Product Change Notice (PCN)

PCN Number: **PCN-0381032R-01**

Product(s) Affected: *GF0506*

GF0506 Previous Design	GF0506 New Design

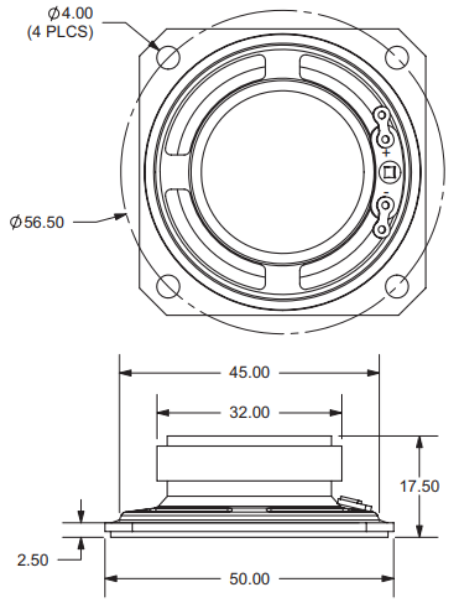
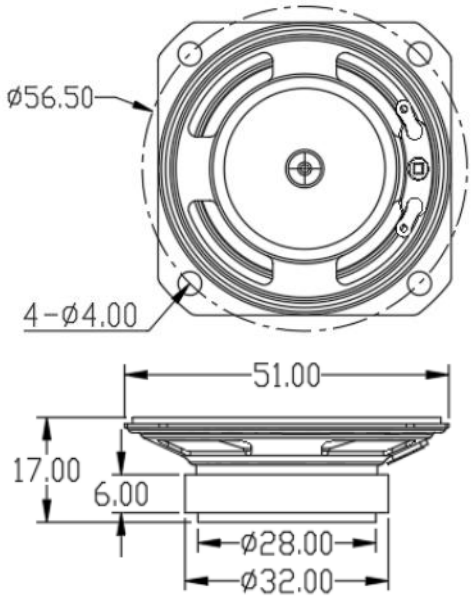
Description of Change: *Sound pressure level increased from 82dB to 83dB at .25W/.5M. Specified Frequency Range tightened from 7.2KHz to 4KHz. Frame size extended from 50mm to 51mm (mounting hole placement unchanged), speaker height reduced from 17.5mm to 17mm. Operating temperature extended to -20°C ~ +70°C.*
